CRIME IMPACT STATEMENT

Land at Irk Street, Manchester

Arts, Music, and Cultural Events Space
(513sqm internal space / 868sqm external
space)

Greater Manchester Police

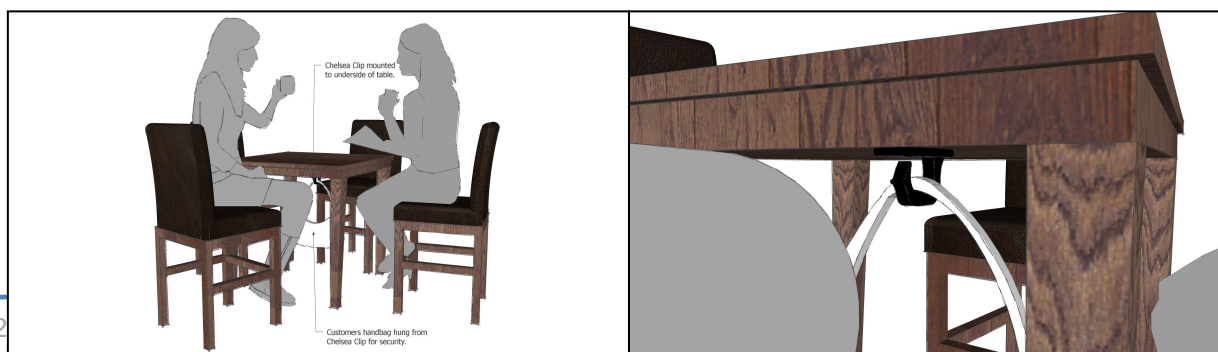
- 3.3.1 Any shipping containers used to accommodate the business(s) and any storage containers used should meet the LPS 1175 standard (or at least adhere to the principles of LPS 1175 certification), to allow management staff too securely store stock and close up the units overnight.

- 3.3.2 Areas restricted to staff should be clearly signed to ensure that patrons cannot use the excuse of getting lost for accessing areas restricted to staff.

- 3.3.3 If any replacements are made to the external fittings of the building (i.e. doors, windows, glazing, shutters) it is highly recommended that they are certified to the standards in the following section (4 - Physical Security).

- 3.3.4 Due to the high levels of crime within the area and the possibility of reusing the existing vehicle door for the main entrance it is recommended that this entry/exit point is staffed

- 3.3.5 Staff lockers should be provided so that staff can safely store personal items during the working day.
- 3.3.6 The cash management strategy at the end of trading day should be robust and remove the opportunity for crime and theft of cash. Consideration should be given to using a Cash & Valuables in Transit company to collect takings at the end of the day, reducing the risk to staff carrying this out presently and reducing the opportunities for theft.

- 3.3.7 Signage should be provided communicating that no cash is stored in the venue overnight.
